Docket Number:	22-BSTD-01
Project Title:	2025 Energy Code Pre-Rulemaking
TN #:	251562
Document Title:	Taylor Engineers Comments on Heat Pump Baselines for Offices and Schools
Description:	N/A
Filer:	System
Organization:	Taylor Engineers
Submitter Role:	Public
Submission Date:	8/9/2023 4:17:37 PM
Docketed Date:	8/9/2023

Taylor Engineers Comments on Heat Pump Baselines for Offices and Schools

To: CEC
From: Jeff Stein
Subject: Docket Number: 22-BSTD-01 (Heat Pump Baselines)
Date: August 9, 2023

Figure 1

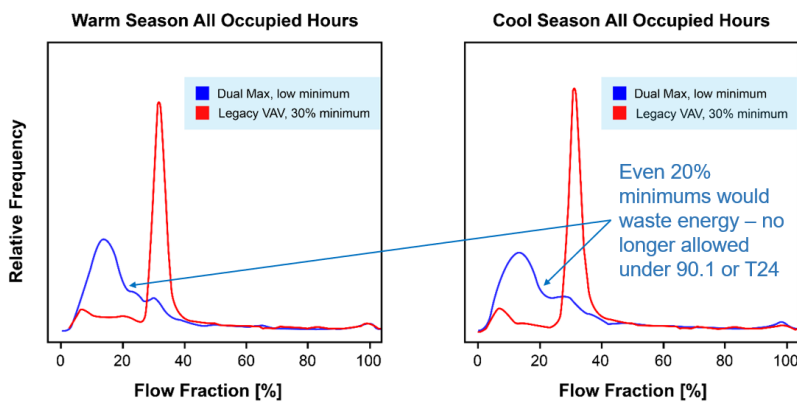
1. [ASHRAE RP-1515](#) was a long term study of many office buildings with thousands of zones. When the VAVR zone minimums were reduced from 30% to 10-15% almost all zones spent almost all their time at the new zone minimums, meaning that real zone loads are rarely more than 10-15% of their design values. See Figure 1 below.

Figure 2

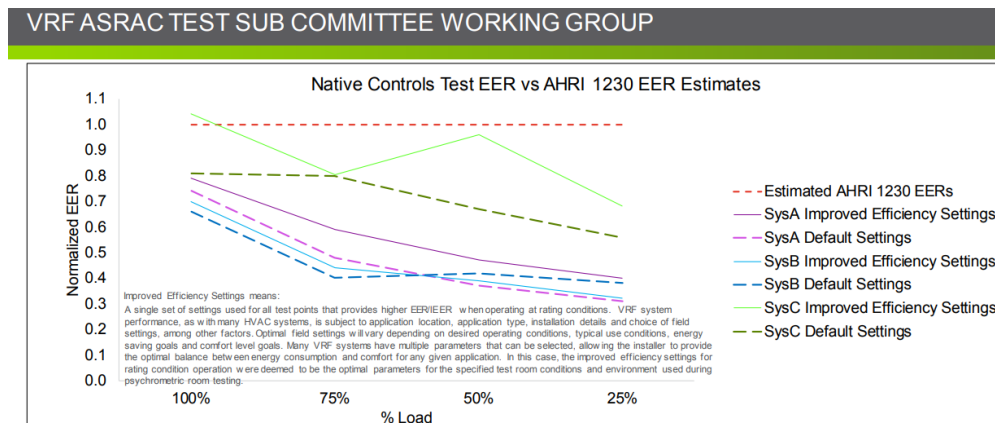
- v. Other features of VAVR that are often modeled incorrectly are supply air temperature reset and duct static pressure reset.
 - b. Third party testing of VRF equipment by [PG&E](#), [Guidehouse](#), and [DOE](#) has shown that the efficiency claims by the AHRI ratings are overstated, particularly in terms of heat recovery efficiency. For, example, Figure 2 shows that the real measured EERs are about half of what the ratings predict, i.e. VRF uses twice the energy expected by CBECC.
